Whale Tail 2024 Annual Open Pit Geomechanical Inspection

February 3, 2025

RE: Meadowbank Complex - Amaruq Site - 2024 Annual Open Pit Geomechanical Inspection

Observations – Northwest Wall Failure

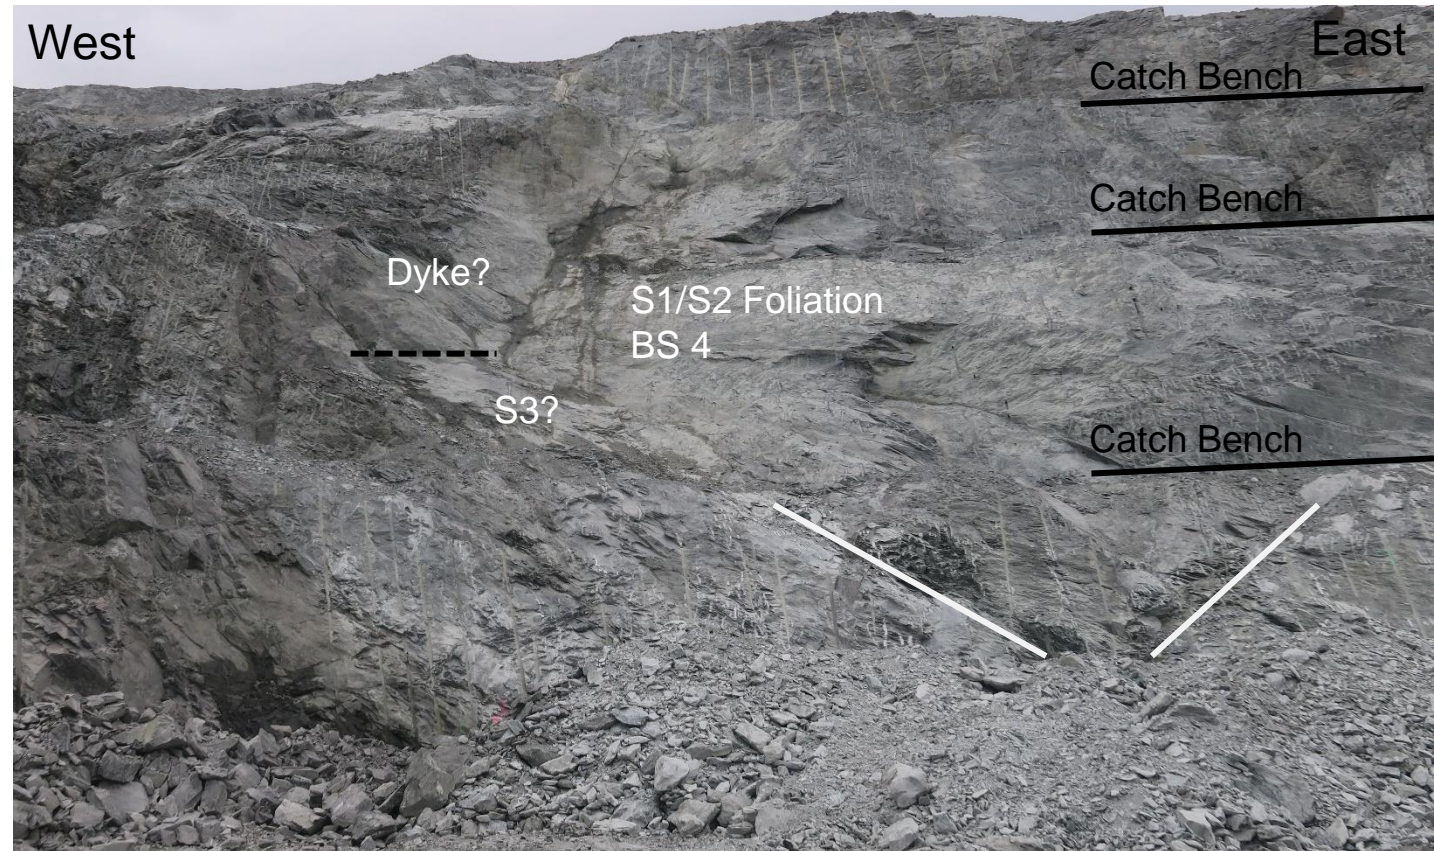
- Four bench scale wedge failures occurred on the Northwest Wall between September 2023 and July 2024, linking together to form a multi-bench scale failure. The tonnage of the individual failures ranged from 300 to 9600 tonnes, with a cumulative tonnage of 17,800 tonnes. This is the largest failure in the open pit to date.

- The failure ultimately formed a compound wedge:
 - The east side of the failure is parallel to the S1-S2 foliation and occurred along Brittle / High-Strain Structure 4. This is categorized by AEM as a Major Structure.

- The upper west side of the failure appears to have occurred along a dyke (either I3 or I4).
 - The control for the lower west side of the failure is less clear but is thought to be the S3 foliation.

- The initial failure was forecast by the slope stability radar. The area was beamed off for the subsequent failures.
- Another potential wedge formed by the same structures is present on the current bench (outlined in white). The mine has attempted to scale down this wedge several times.

- The loss of the catch benches increases the rockfall hazard for mining activities below this area. While a temporary rockfall berm was in place at the time of the annual inspection, it will be removed during the mining of the next flitch. It is recommended that a permanent rockfall berm be constructed below this area, either on the current bench or the next one.

- The LOM and Budget mine plans should be reviewed to assess whether similar bench or multi-bench scale failures are possible on the Brittle / High-Strain Structures, Dykes, and the S3 foliation. It is expected that the likelihood for these failures will reduce as mining extends to depth because the dykes are most prominent at the west end of the open pit.

- Potential future multi-bench scale failures should be flagged in the LOM/ Budget mine plan. A monitoring plan should be developed and the mine plan reviewed to mine out, reduce the size of, or manage the failure. It is expected that potential bench scale failures can continue to be managed using the existing tactical measures

- It is recommended that the Brittle / High-Strain Structures be mapped and the results used to validate/refine the structural model.
- Rockfall reports were completed for each of the failures. However, the potential for similar failures (e.g., on the subsequent bench) was not identified. Trends, such as these repeated failures along the Brittle / High Strain Structures should trigger a more detailed review and back-analysis. The objective is to understand the root causes and to better anticipate or eliminate similar failures in the future. This is discussed in more detail in the Ground Control Program section of this presentation.

Observations - Northwest Wall - Wedge

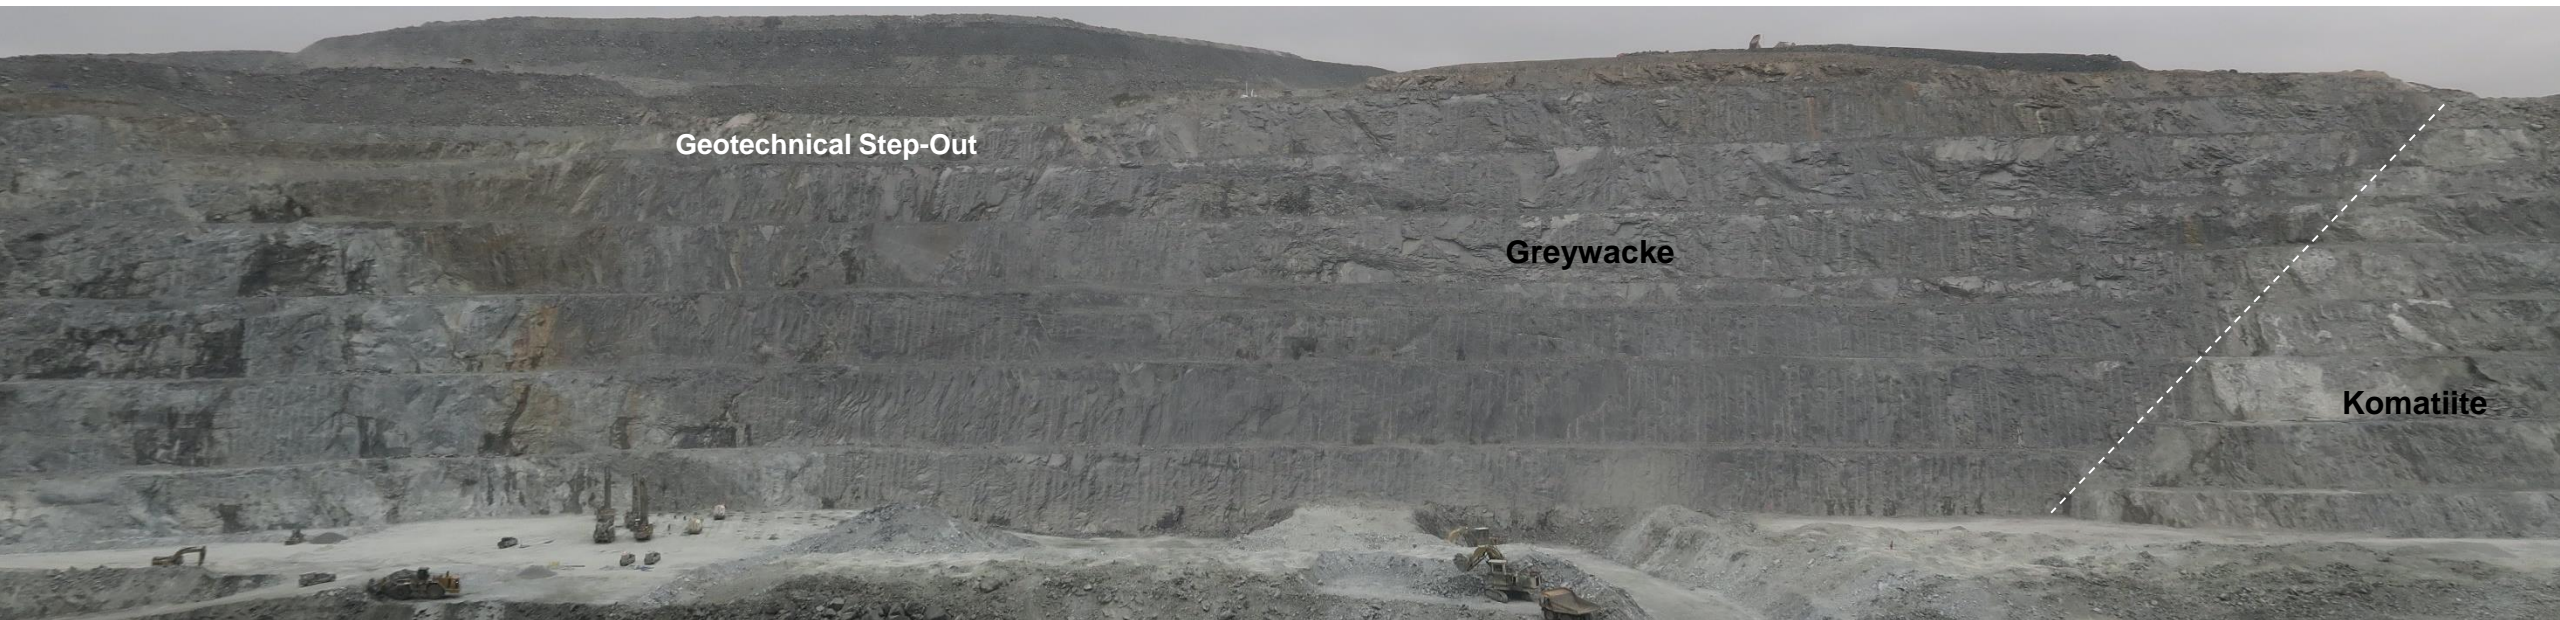
- A wedge is present above the ramp (lower photo).
- The potential for a wedge was originally identified in 2020. Ravelling of material over time has resulted in the wedge becoming more prominent. It is believed that most of the ravelling occurred when the Phase 2 Ramp was established below this area between December 2022 and January 2023.

- There is a partial bench between the wedge and the Phase 2 ramp. However, it is likely that material would reach the ramp if the wedge failed.
- The wedge is a focus of the regular visual inspections and the drone surveys. The mine has also defined a specific radar alarm for this area.

- No significant changes in the condition of the wedge were observed between the 2023 and 2024 annual inspections.
- Continue to monitor this area closely, both from the ramp and the overlook above. If further deterioration is observed, further mitigation will be required (e.g., knocking down the wedge).

Observations - Northeast Wall

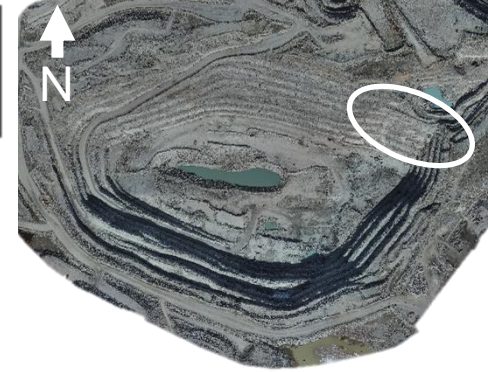
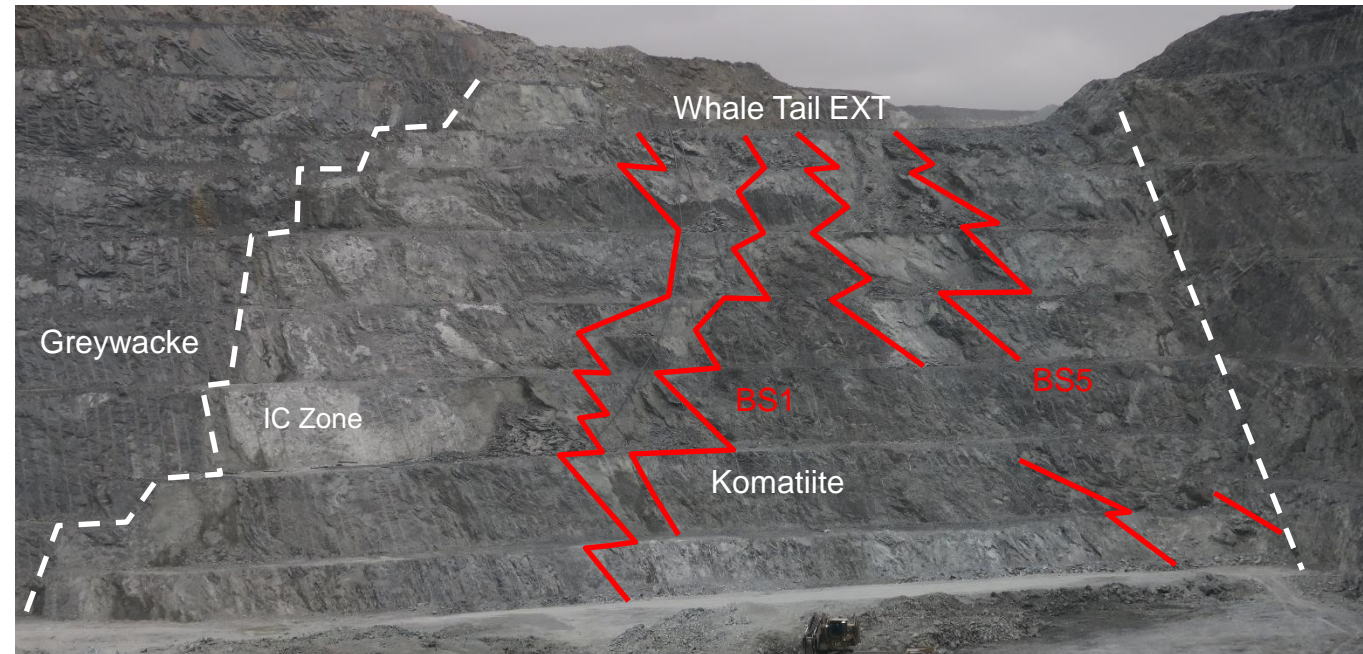
- Final wall in Design Sector D4K.
- This sector is within the Komatiite and has been characterized by a series of bench scale failures associated with the weak rock mass and the High-Strain / Brittle Structures (select structures are shown in red below). The slope design was revised in December 2021 and has been successful in managing the performance of the slope.

- Four rockfalls and bench-scale failures have occurred in this sector since the last annual inspection, ranging in size from 23 to 480 tonnes. All of the failures occurred behind berms between April and July 2024 and the failure mechanism is consistent with previous failures in this sector.

- It is expected that rockfalls and bench-scale failures will continue to occur. The wall continues to be a focus for the Rock Mechanics team. The Working with Komatiite Procedure introduced in 2024 is a key tool for managing the geotechnical risk in this sector.

Observations - East Wall

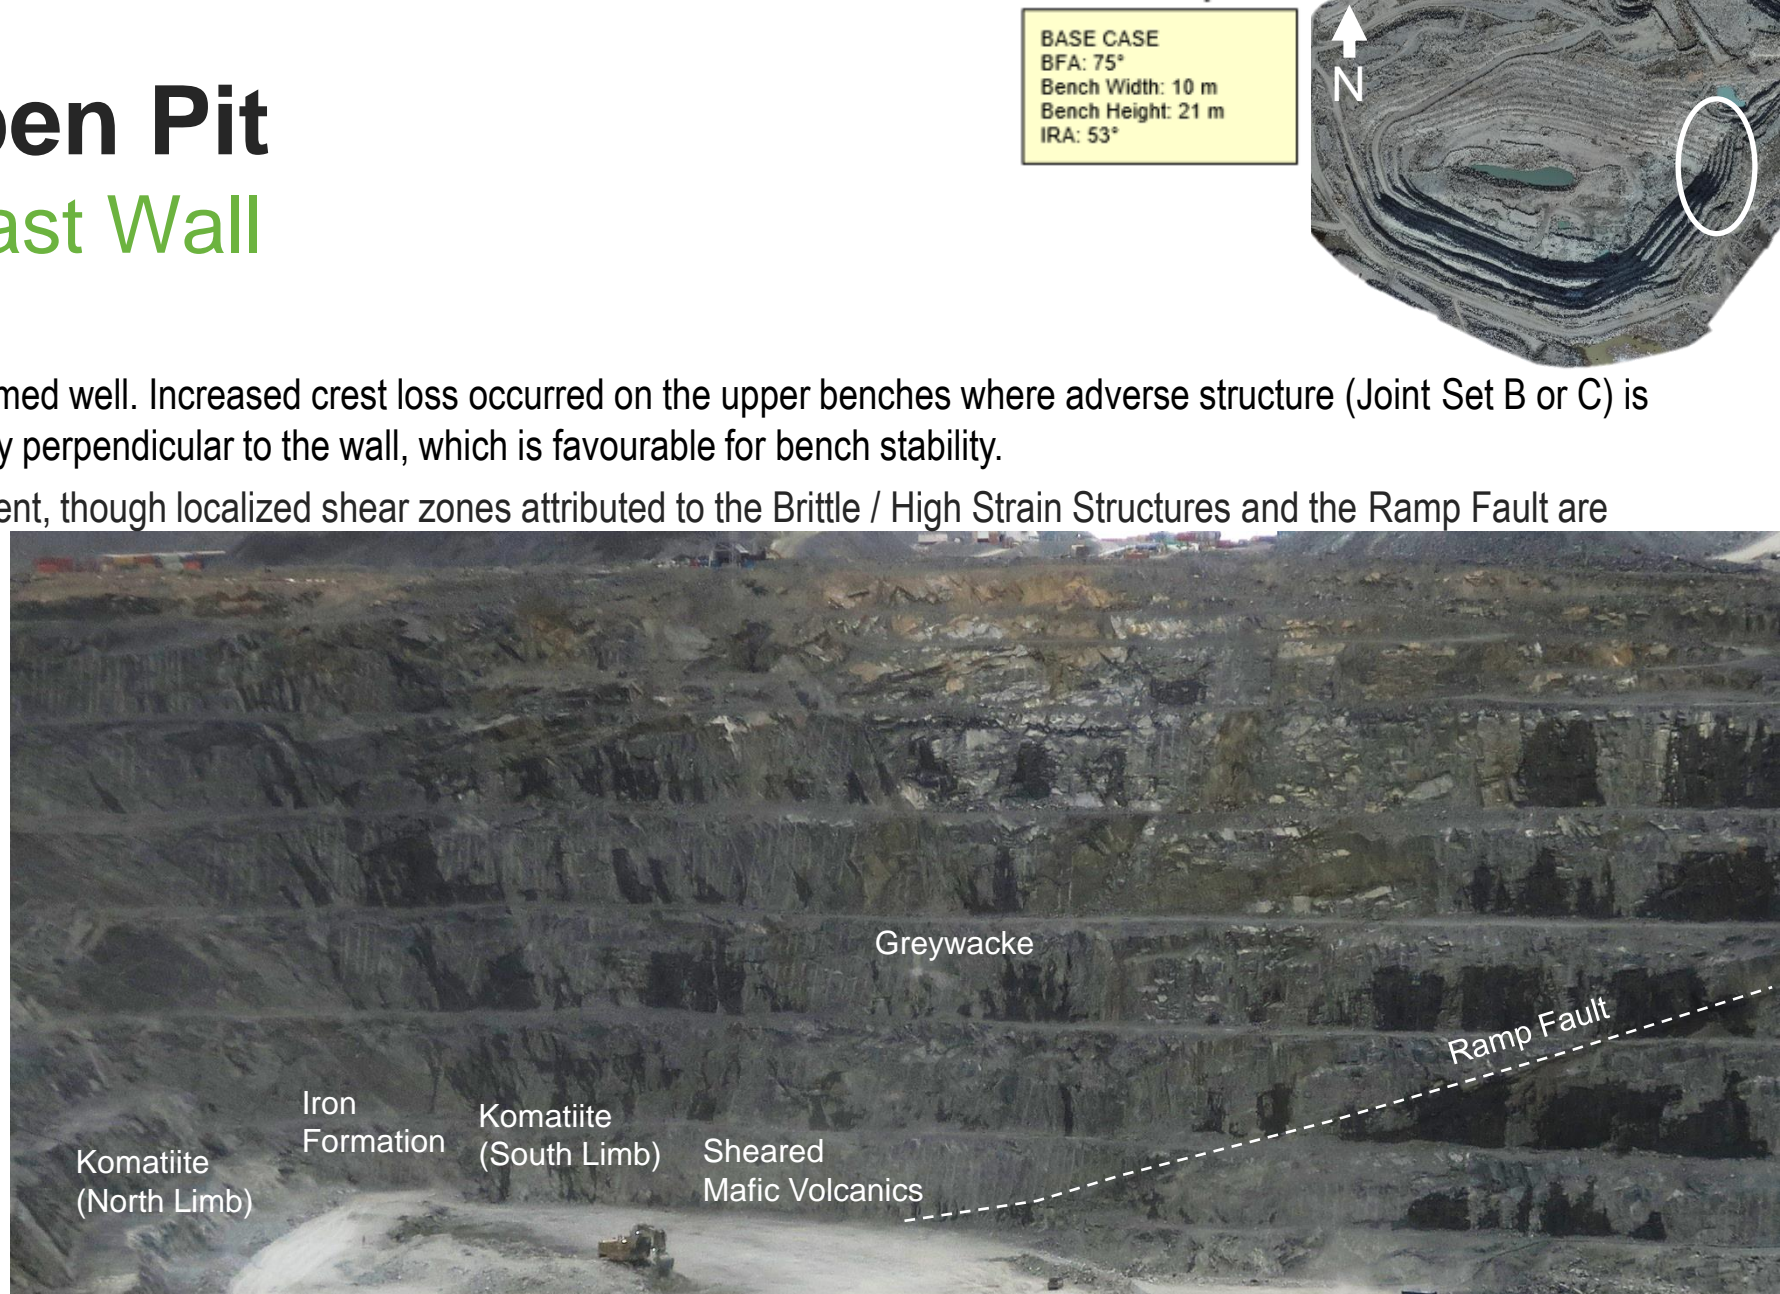
- Final wall in Design Sector E4.
- The benches have generally performed well. Increased crest loss occurred on the upper benches where adverse structure (Joint Set B or C) is present. The foliation strikes roughly perpendicular to the wall, which is favourable for bench stability.
- The rock mass is generally competent, though localized shear zones attributed to the Brittle / High Strain Structures and the Ramp Fault are observed within it.
- These structures represent a potential rockfall hazard, but this has not been an issue to date.
- There is an interval of intensely foliated/sheared Mafic Volcanics in the lower benches. This has not significantly impacted bench performance to date. However, the extents of this unit should be reviewed and the potential impact on subsequent benches assessed. It may be associated with Brittle / High Strain Structure #3.

Observations - Southeast Wall

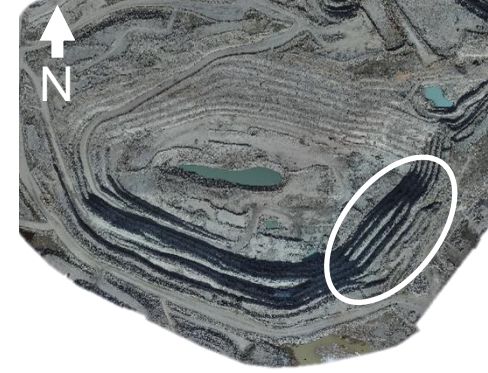
- Final wall in Design Sector F6
- The slope geometry recommendations for this sector were adjusted in late 2021. A catch bench width of 16 m, was thought to be achievable, with the expectation of backbreak in the order of 8 m along Joint Set C. The benches initially performed better than expected, with backbreak typically less than 4 m, and AEM reduced the design catch bench width to 13 m in March 2023.

- Subsequently, the 5046 bench experienced > 6 m of crest loss over significant intervals of the catch bench. While rockfalls have not been reported or observed in this sector to date, the potential for rockfall exists.

- As the ramp will pass below this sector, a decision was made to add an additional catch bench (5034). The bench was being scaled at the time of the visit, but it also appears to have experienced significant crest loss.

- Different alternatives for managing the rockfall hazard were discussed during the visit. AEM is planning to install a Geobrugg rockfall barrier along the crest of the 5034 catch bench where the catch bench capacity has been lost. This is endorsed.

Observations – South Wall Failure

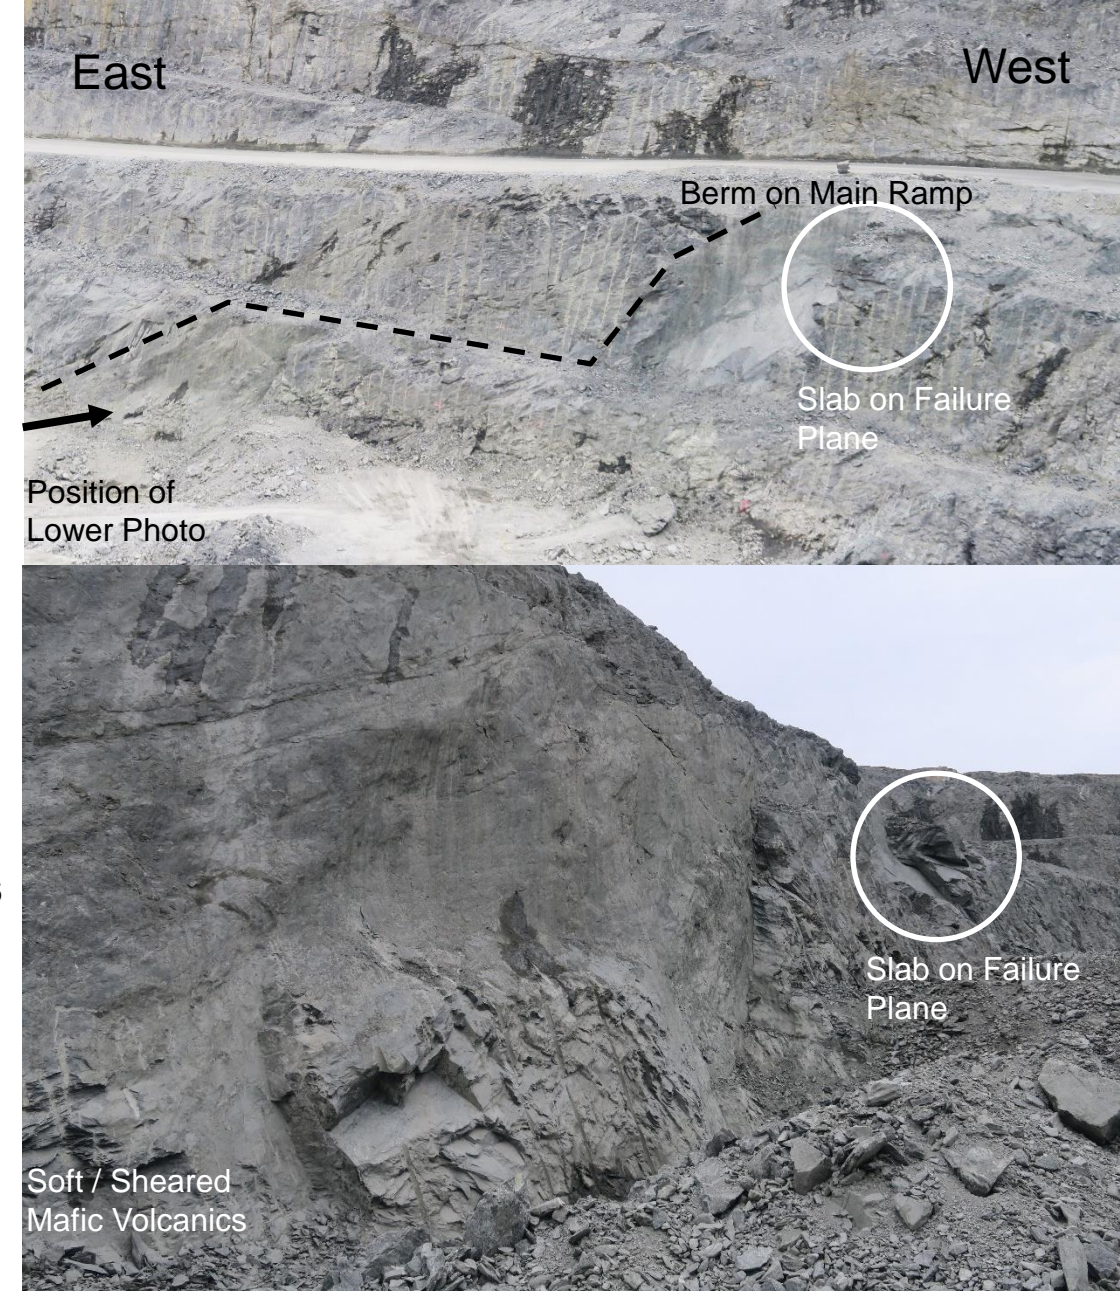
- On June 16, 2024, a 500 tonne bench scale failure occurred below the ramp (see image at upper right). Most of the material was retained on the catch bench immediately below the failure but some reached the next bench where a pattern was being drilled.

- Evidence of the impending failure was captured by the SSR but was not noticed by the Rock Mechanics team. The SSR alarmed at approximately the same time as the failure occurred. As a result, no warning was given for the failure.

- Two drills were working on the pattern directly below this bench at the time of the failure. No personnel were hurt or equipment damaged, and the area was barricaded.

- A specific monitoring plan was developed to allow the failure to be cleaned up and the pattern drilled and blasted. The slope stability radar was moved to directly in front of the failure, mining was restricted to day shift and a spotter was used. This was well done.

Observations - West Wall

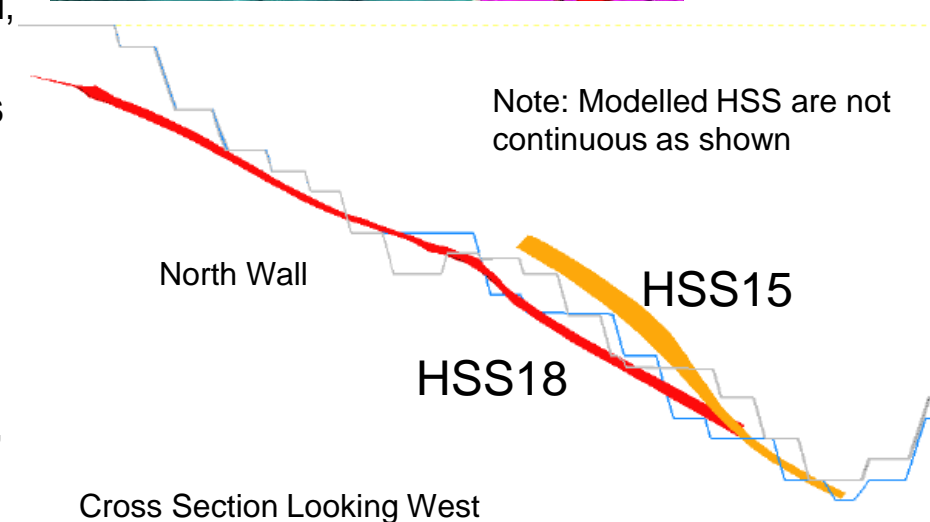
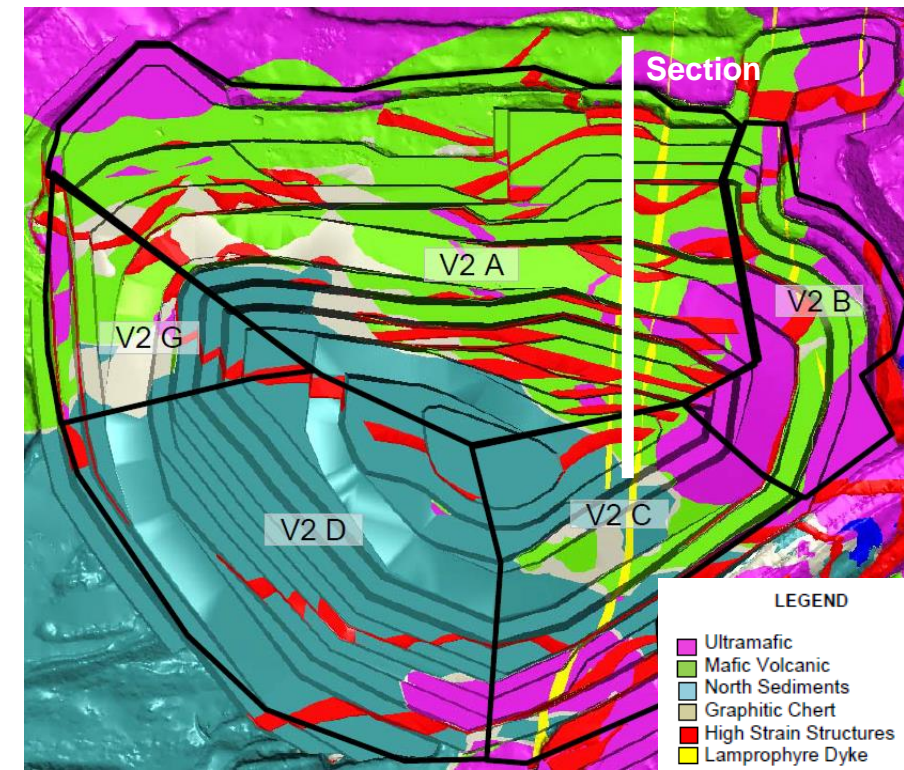
- The pushback of the west wall is in progress. Only a single bench was exposed at the time of the annual inspection.
- The rock mass structure is favourable in this sector and the bench has performed well.

- The bench is expected to be established in a combination of Mafic Volcanics and Komatiite. An interval of Komatiite was observed towards the northern end of the wall (outlined below). It is important for the performance of the North Wall that the Komatiite not extend into that wall in significant quantities. Comments on the design of the open pit are provided on the next slide.
